North Portland Aquatic Center: Phase 2 / Cycle 2 Community Gathering Summary – August 21, 2025

A Community Gathering was held on Thursday, August 21, 2025 at Roosevelt High School as part of the second cycle of engagement for the North Portland Aquatic Center (NPAC) design process. The purpose of this engagement was to present the design options, hear input on preferences, and gather info on which design is most preferred to most forward.

Beacon in the Park

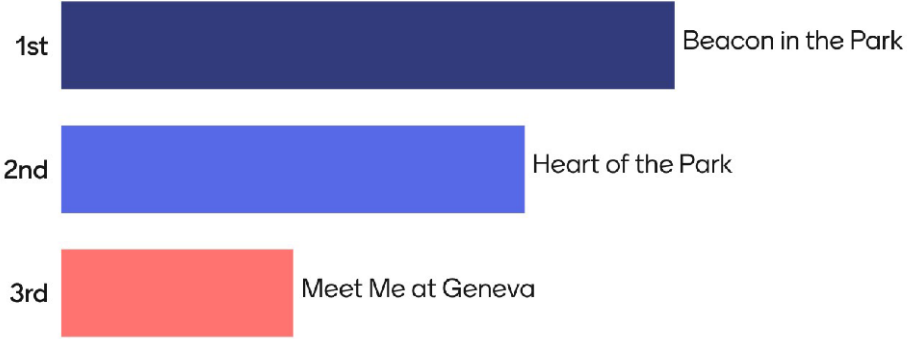
- Most green space, which is good
- Foresees congestion at the entry/exit to traffic on Fessenden, since they are one and the same
**we note that this condition is the same in each, we should note either some signage or create an in and out to the parking.

- Keeps the most number of activities (i.e. tennis), which is good. Notes that tennis courts can be used for rollerblading, learning to hit baseballs, etc. and would like to keep it.

- Removing the nuisance trees would be good!! People who live there say their gutters flood and that's it's a huge pain
- Like that the design allows for the exterior to see inside and see the slide, really would feel like an aquatics building

- Pavilion should be moved to South-East of the green space, and be more separate from the building like in Option 2
 - For performances, might need a service access/road to bring equipment?

- Trees that are removed are nuisance trees. Not an issue.
 - Like to bring a high quality architecture to the neighborhood and see it from the street.

- Add parking where the tennis courts are located for access to the park.
 - Like the solar potential
 - Like the peak in the NW corner.
 - Like the access to the space. Like that only service vehicles use Geneva.

- Would like to put the pavilion on the end of the field like Heart of the Park.
 - Do not like the location of the splash pad in relation to the pavilion. Other options allow view of the splashpad and the pavilion simultaneously.

- Bigger splash pad, similar to Heart of the Park.
 - Would prefer the layout of the amenities of Heart of the Park in this option.
 - Would prefer the second story spectator seating.
